## Simplifying Equation 33-15.

In July meeting we have updated Figure 33-26 and Equation 33-15 for D1.8.

Figure 33-26 – linrush-2P and linrush current and timing limits, per pairset in POWER\_UP state

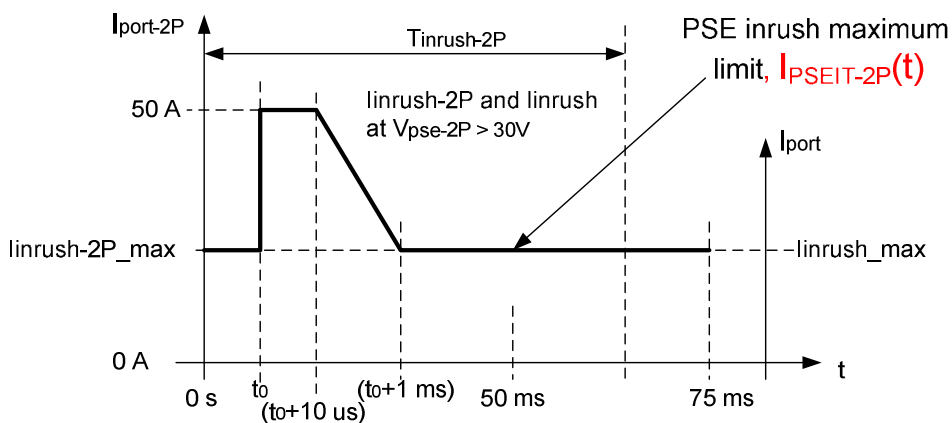
1. In Figure 33-26 there is text missing marked in **RED**.
2. Equation 33-15 can be simplified per the work done in:  
[http://www.ieee802.org/3/bt/public/may16/darshan\\_18\\_0516.pdf](http://www.ieee802.org/3/bt/public/may16/darshan_18_0516.pdf) (See Annex A for reference in this document.

1. Update Figure 33-26 with the additions marked RED:

Figure 33-26 – Iinrush-2P and Iinrush current and timing limits, per pairset in POWER\_UP state

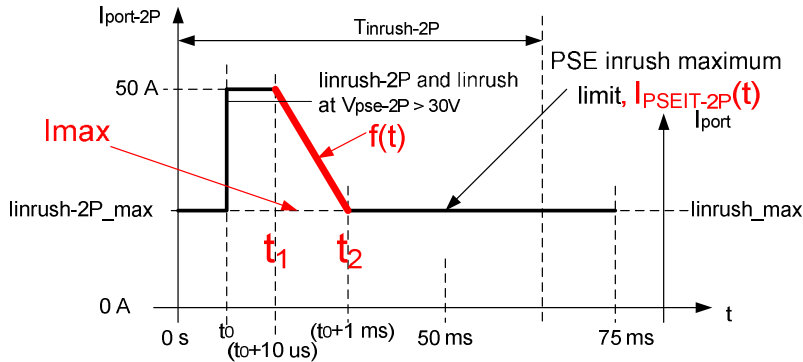
The following derivation will address  $f(t)$  part which is marked in red:

$$I_{PSEIT-2P}(t) = \left\{ \begin{array}{ll} I_{max} & \text{for } 0 < t < t_0 \\ 50 & \text{for } t_0 < t < (t_0 + 10 \times 10^{-6}) \\ f(t) & \text{for } (t_0 + 10 \times 10^{-6}) < t < (t_0 + 0.001) \\ I_{max} & \text{for } (t_0 + 0.001) < t < 0.075 \end{array} \right\}$$

From observation, the value of equation 33-15 in the range 10usec to 1msec in D1.7 should be the same as in D1.8 in the range  $(t_0 + 10 \times 10^{-6}) < t < (t_0 + 0.001)$  without being dependent in  $t_0$  since its slope described by  $f(t)$ , the maximum value (50A) and the minimum value (Iinrush-2P\_max or Iinrush which is described by  $I_{max}$ ) will remain the same.

$t_0$  is limited to 49msec (50msec maximum PD inrush time duration minus 1msec PD max transient time during PD inrush period).
